EN020022: AQUIND Interconnector

Application by AQUIND Limited for an Order granting Development Consent for the proposed AQUIND Interconnector (“the AQUIND Interconnector project”)

Secretary of State Re-determination of Application: Request for Information

Unique Reference: EN020022

Lovedean: Proposed Solar Farm Site Plan

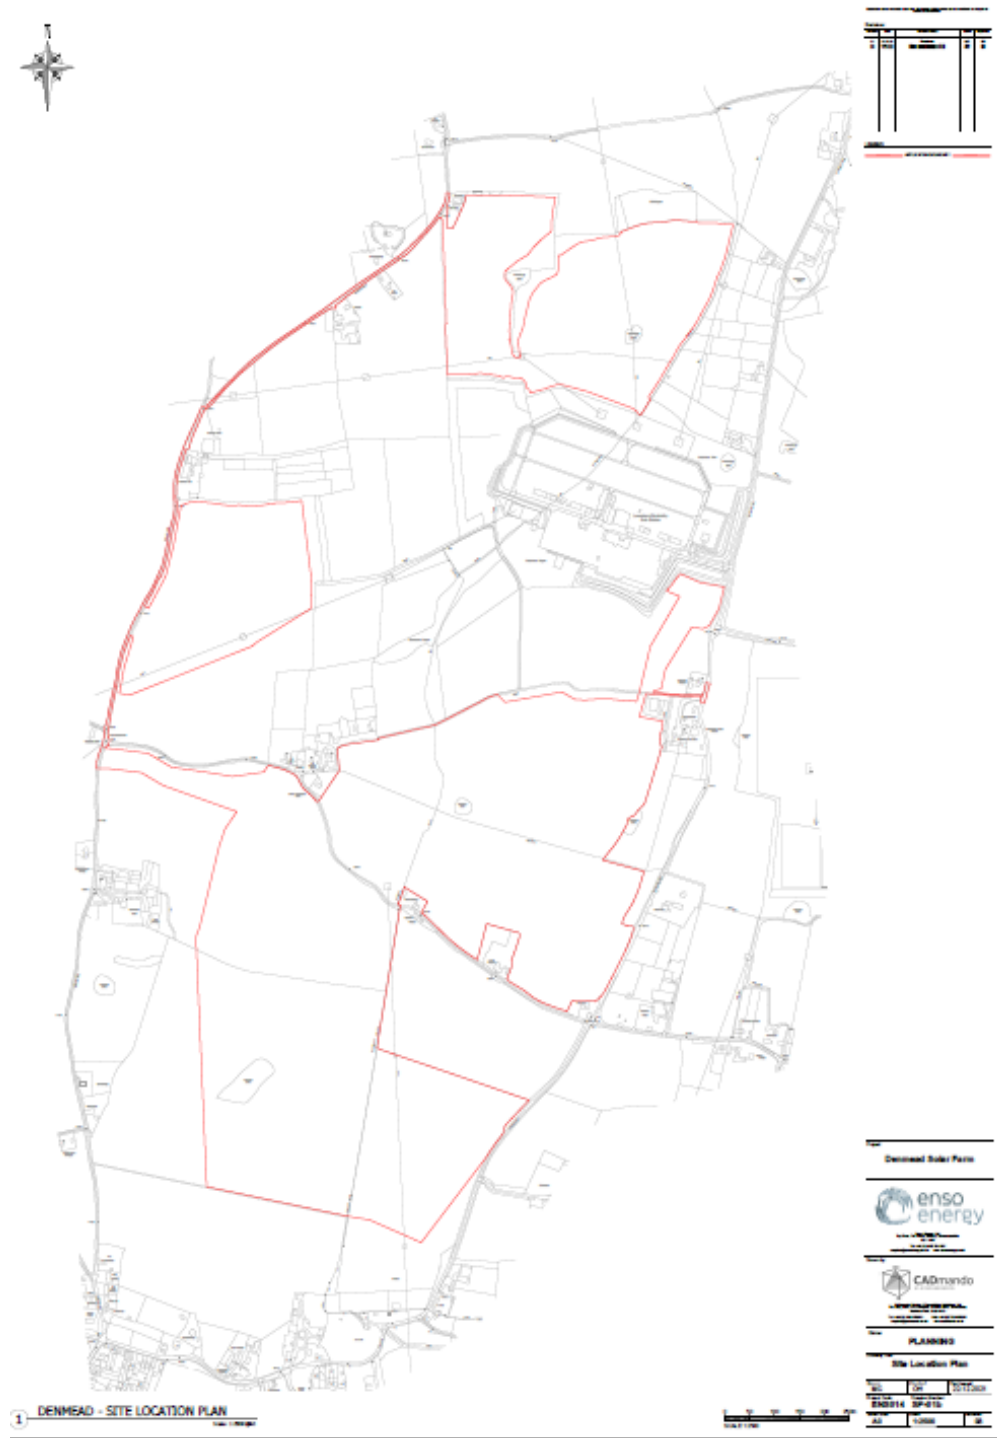
A planning application has been submitted for a proposed solar farm with a battery storage facility on land that lies to the north, west and south of the Lovedean Sub Station. The application was received on 18 February 2022. The WCC application reference number is 22/00447/FUL. The full description of the application is:

Attached to this letter as appendix A is a copy of a plan that shows the extent of the application site.

Figure 3: AQUIND Interconnector project boundary in relation to the site boundary

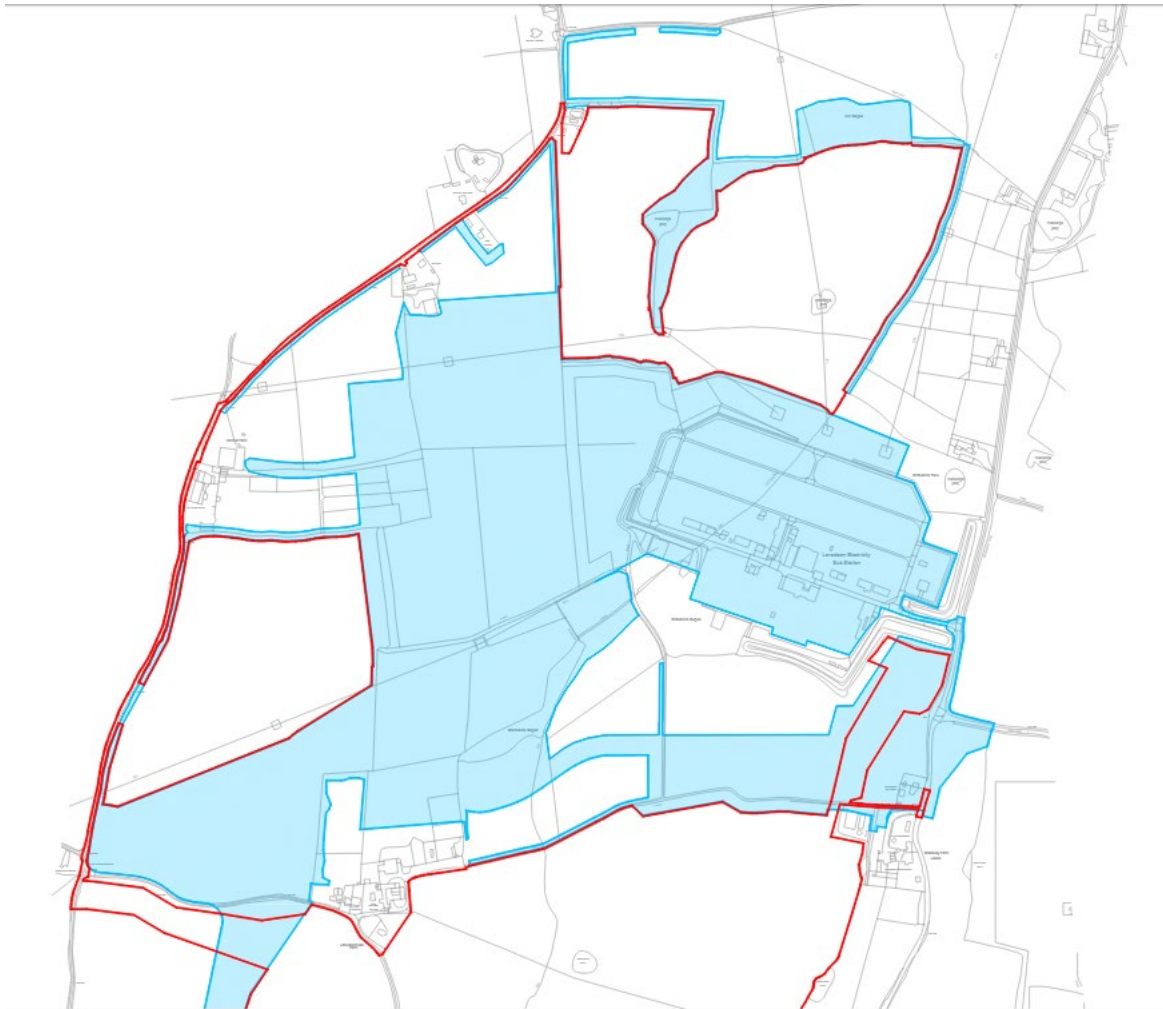
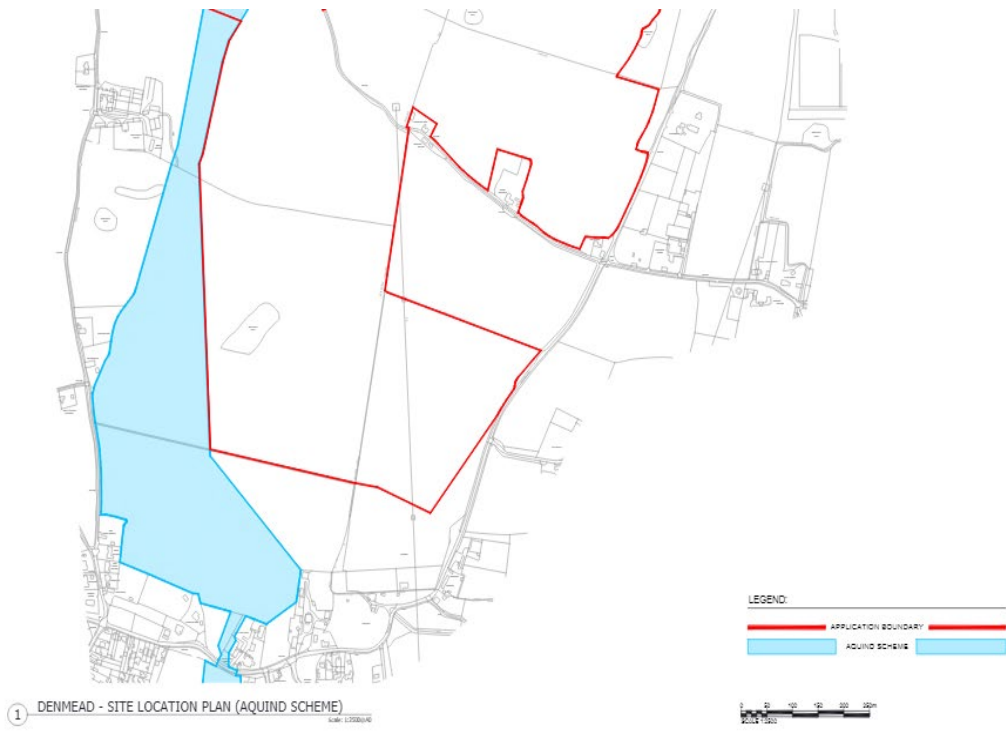
- 4.2 The solar farm scheme developer has sought to avoid any overlap between the two schemes and has intentionally drawn their red line inside the Aquind application site boundary to avoid such an overlap. This is most readily apparent on the field boundaries where the solar farm boundary has been drawn several metres inside the hedgerows that Aquind intend to exercise a degree of control over and are annotated as New Landscape Rights on their Land Plan sheet 1 of 10 revision 05 (REP7-003). For assistance, attached as appendix B is a copy of a plan that shows the two application sites.

Notwithstanding the above intention, the proposed Enso solar farm scheme does overlap the proposed Aquind scheme in a number of aspects and these will be considered below.

The solar farm red lined application site physically overlaps the Aquind site in the following areas:

- a. The main access to the solar farm site will be via Broadway Lane Denmead Farm Access. Aquind has identified this as an access to the land at pre commencement stage.

- b. The proposed solar farm cable route leading to the Lovedean sub station crosses the proposed Aquind access roadway.
- c. The proposed solar farm cable route that would take the power output from the two parcels of land off Old Mill Lane and which runs down Old Mill Lane would leave the highway and enter the field at The Crossways where Old Mill Lane becomes Denmead Lane. The solar farm internal cable route would cross the north south route of the Aquind cables.

- d. The solar farm scheme proposes to use the two existing field entrances off Old Mill Lane. The solar farm red lined application site does included sections of hedgerow adjoin these two field accesses. Aquind propose to protect and manage this hedgerow as a screening feature.

- e. In addition to the above, the solar farm proposal has included a length of Old Mill Lane within its red line to enable a cable to be laid in the road to connect those solar generating sites to the schemes new sub station. This red line runs down the hedgerow that Aquind propose to protect and manage as a screening feature.

Regarding point (a), there is a proposal (not finalised) that Aquind would use this as their pre-construction access to get onto the land to start the establishment of their new access and the new roadway that would lie to the north.

Concerning points b and c, these are viewed as technical matters in terms of which cable is laid first and the separation depth that needs to be created between them.

Regarding points (d) and (e), the Aquind scheme identifies the hedgerows on the eastern side of Old Mill Lane as contributing to the screening of the main site and it is proposing to take a degree of control over those features as part of their "New Landscape Rights" initiative. These features are shown on the Lands Plans Sheet 1-10 revision 05 (REP7-003).

Enso have stated in email exchanges with the Council that it is not their intention to remove or cut back any of the hedgerows adjacent the two field entrances. Accordingly, these hedgerows would not be affected by the proposed Solar Farm scheme.

The use of the hedgerow on the eastern side of Old Mill Lane as the red line to the application site is not considered to imply any intention to affect that feature as part of the laying of the cable in the road. Its use is viewed as simply indicating the highway limits on that side of the lane.
